Village of Arlington Heights
Conceptual Plan Review Committee
Community Room, 3rd Floor
Arlington Heights Village Hall
33 S. Arlington Heights Road
Arlington Heights, IL 60005
December 13, 2017
7:00 PM

Item: Hearts Place - 120-122 E. Boeger Dr. - T1614

VILLAGE OF ARLINGTON HEIGHTS STAFF DEVELOPMENT COMMITTEE REPORT

Temp File Number: T1614
Project Title: Hearts Place PUD
 Amendment
Address: 120-122 E. Boeger Dr.
PIN: 03-08-100-053, 03-08-100-054

SITE PLAN
1/32" = 1'-0"

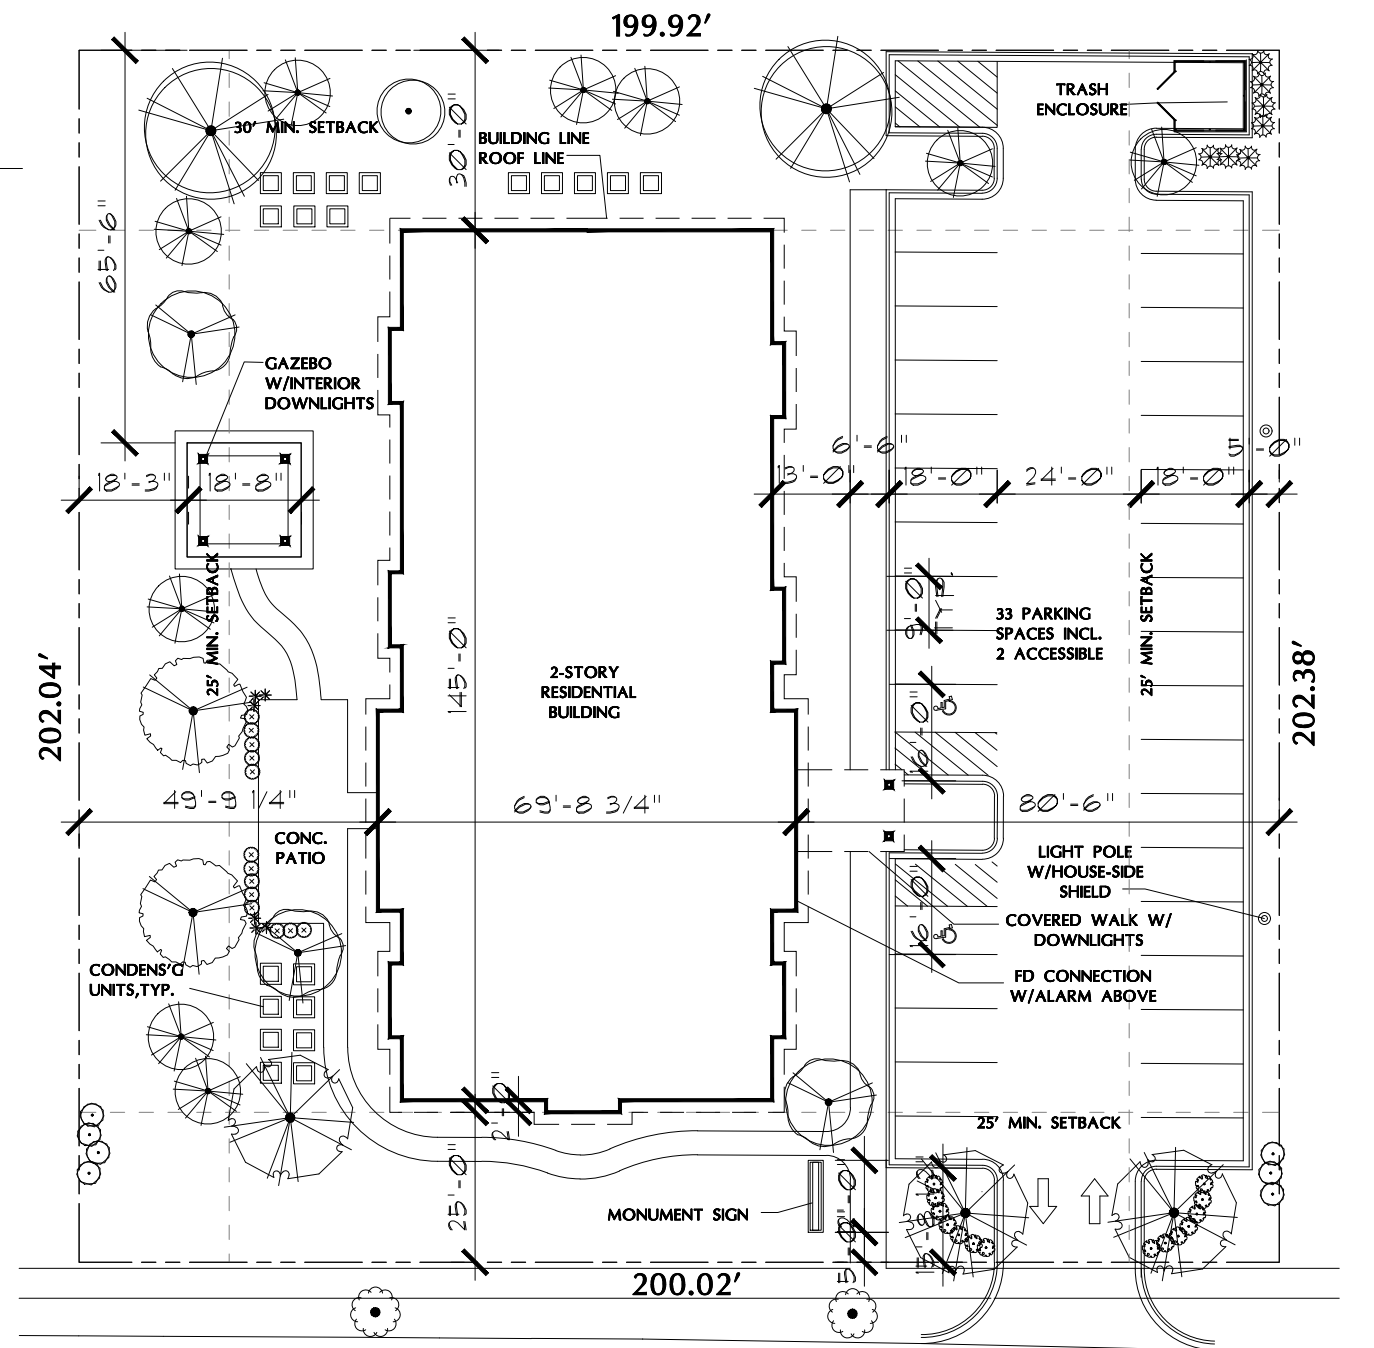
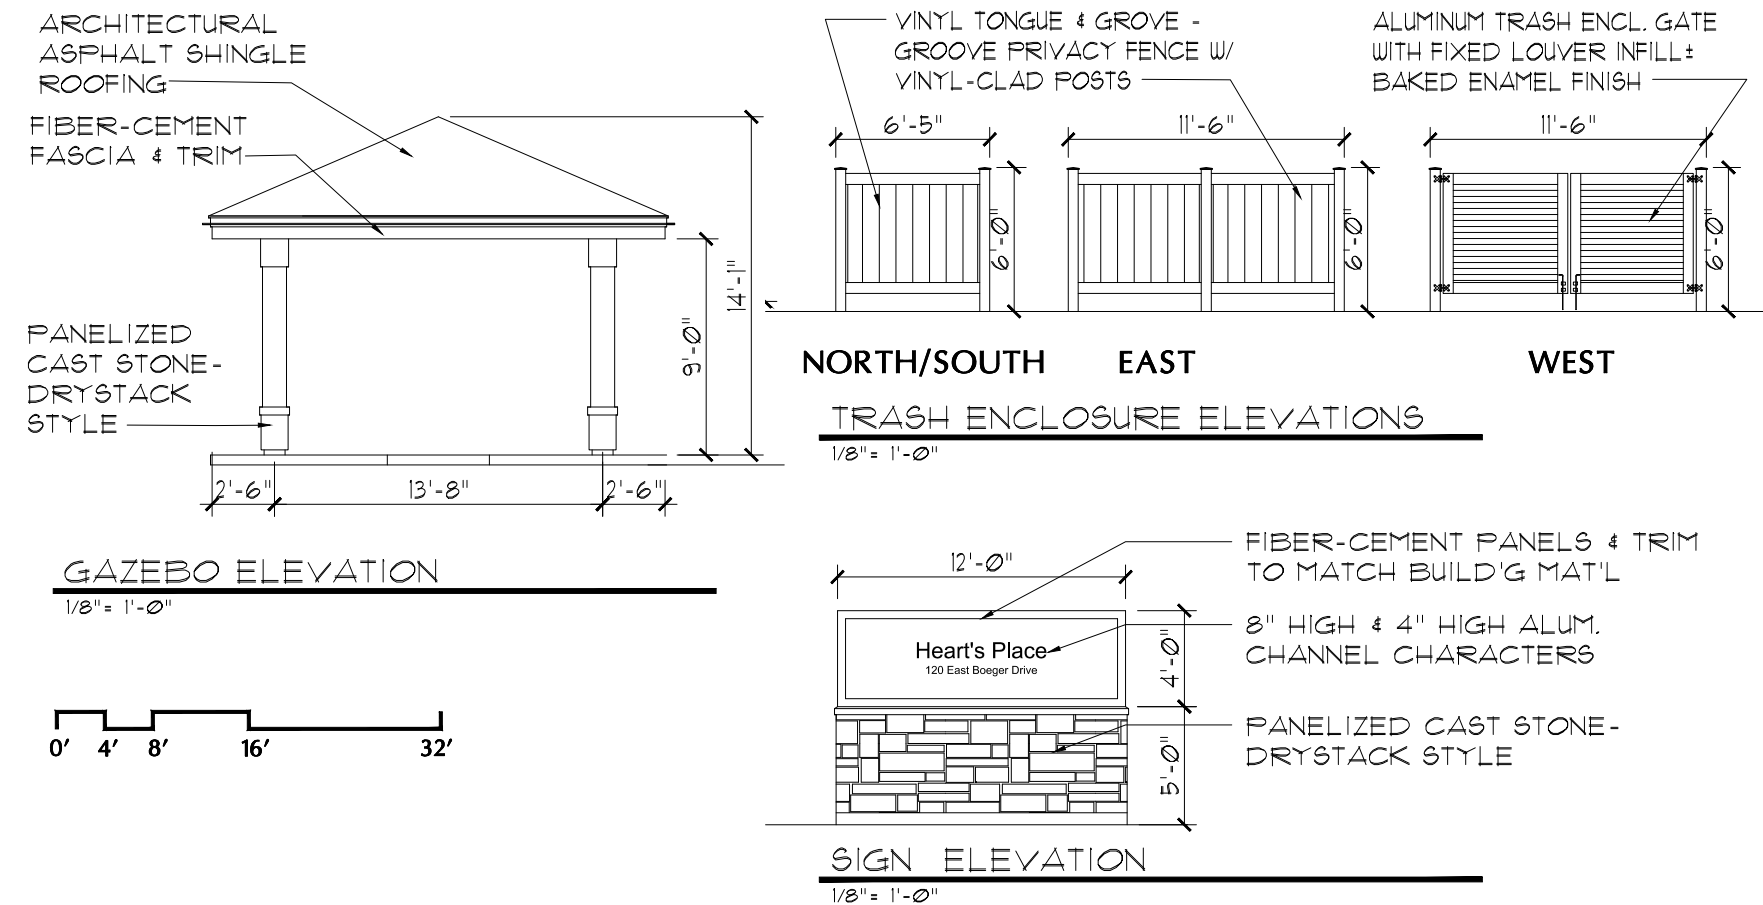
The site will remain unchanged relative to the original approval as the proposed changes relate to the interior of the building. Therefore, the landscaping will also remain unchanged. Due to the increased unit count and layout of the units, there will be some minor changes to the elevations. The petitioner shall submit revised elevations as part of their Plan Commission application to determine if the proposed changes are substantial to an extent where Design Commission re-review will be required.

Staff notes that one of the conditions of approval of the preliminary PUD required the petitioner to coordinate with the property owner of the Popeye's restaurant (located north of the subject property) in order to provide the necessary improvements to the access easement on the Popeye's property which will allow for proper exiting for emergency vehicles from the subject property. Prior to consideration by the Village Board, the petitioner shall provide an update on their communications with Popeye's relative to this improvement, which improvement must be constructed on the Popeye's property.

Relative to parking, 37 spaces are now required due to the unit increase (33 were required under the 16-unit development proposal), and the provided parking remains unchanged at 33 spaces. Therefore, the following variation is required:
